**TOWN OF ADDISON  
BUILDING REPORT**

**Facility Information:** **Facility Name:** Police Substation - Addison Circle

**Accessology Inspector Information:**

**Violation 1** - The entrance door has knob hardware requiring grasping and twisting to operate.

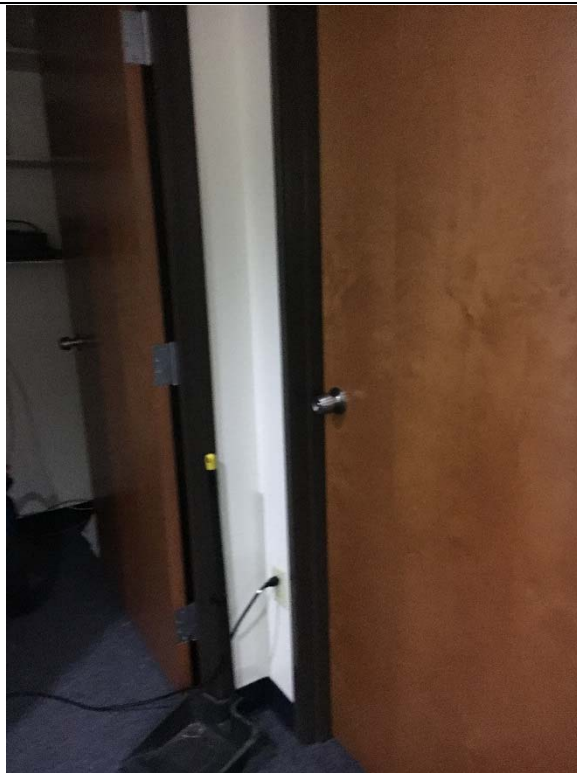
**Violation #1:** The entrance door has knob hardware requiring grasping and twisting to operate.

**Possible Solutions:** Replace with lever type door hardware.

**Violation 3** - The flush control is on the closed side of the water closet.

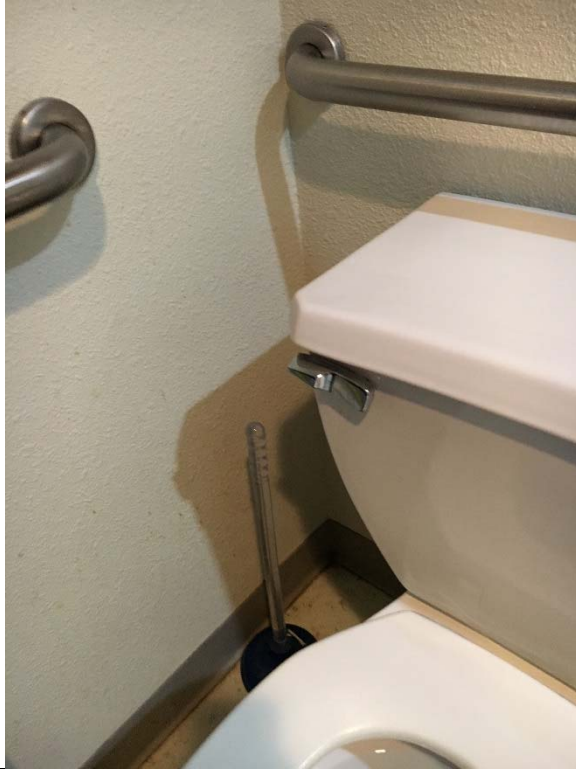
The flush control is on the closed side of the water closet.

Relocate flush control to open side of water closet.

**Violation 4** - There is a cabinet in front of the water closet that blocks the required clear floor space.

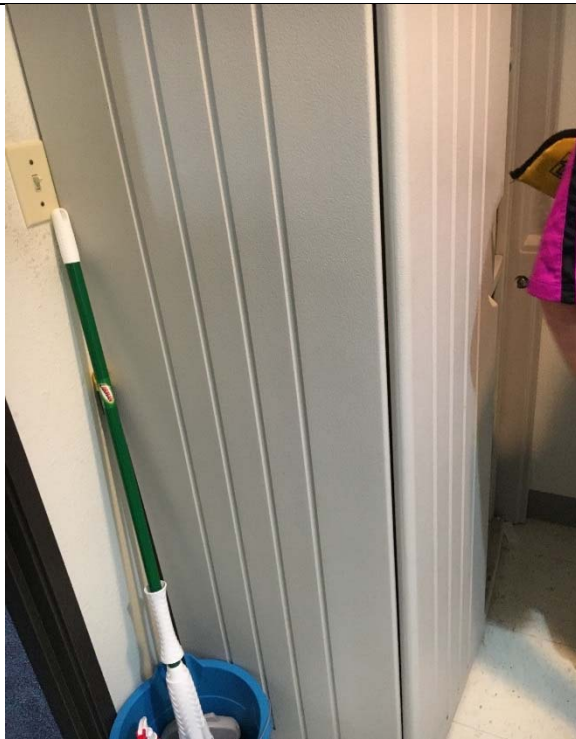
There is a cabinet in front of the water closet that blocks the required clear floor space.

Relocate the cabinet to allow for the required clear floor space.
